## AUBURN CITY COUNCIL

**93-105 Auburn Road & 18 Harrow Road, AUBURN**

### **ADDENDUM TO REPORT CONSIDERED AT MEETING OF 11 DECEMBER 2014**

<b>Applicant</b>	Broadview Group P/L C/- Sjb Planning
<b>Owner</b>	E K Nominees Pty Limited
<b>Application No.</b>	DA-368/2013
<b>Description of Land</b>	Lot 1001 DP 1166744, Lot 1002 DP 1166744, 93-105 Auburn Road & 18 Harrow Road, AUBURN
<b>Proposed Development</b>	Construction of a mixed use development comprising 2 x 14 storey buildings containing a total of 220 residential units & 10 retail tenancies, 'Village Square' and through site link over part 3/part 4 levels of basement car parking with associated provision of landscaping & site services
<b>Site Area</b>	4,849sqm
<b>Zoning</b>	Zone B4 - Mixed Use
<b>Disclosure of political donations and gifts</b>	Nil disclosure
<b>Issues</b>	Reduction in width of Harrow Road tower Exceedance of height limit

# **HARROW ROAD TOWER FLOOR PLAN**

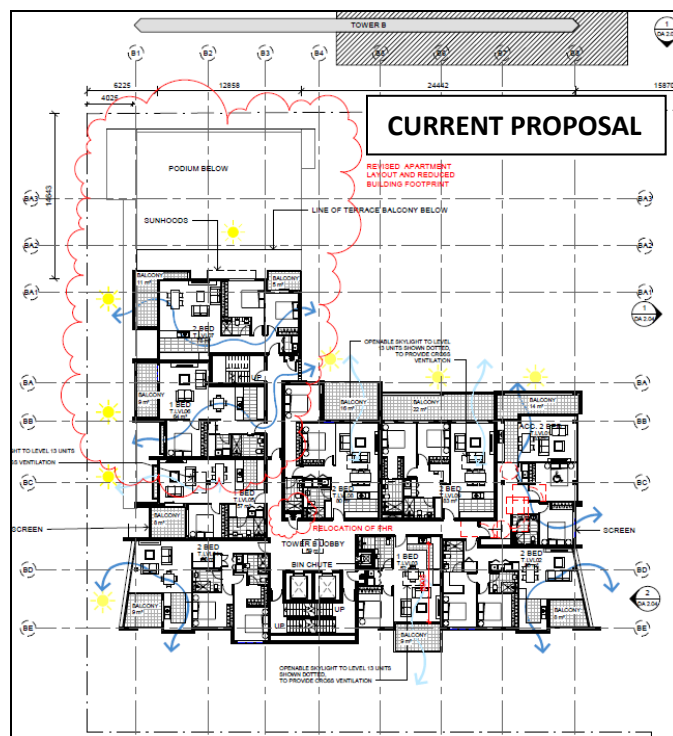
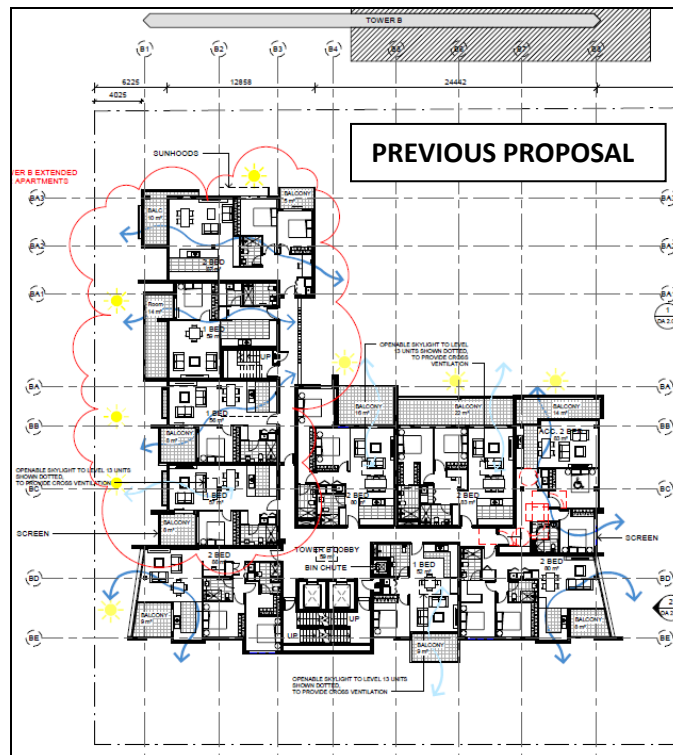
The proposal has been amended to delete a 1 bedroom dwelling from each floor of the tower element of the Harrow Road building, reducing the width of the tower from approximately 44.8m to 31.5m and increasing the northern (side) boundary setback of the building from 7.4m to 14.643m. The treatment of the northern elevation has been retained.

The number of dwellings has been reduced from 229 to 220. All other aspects of the development remain unchanged from that previously proposed.
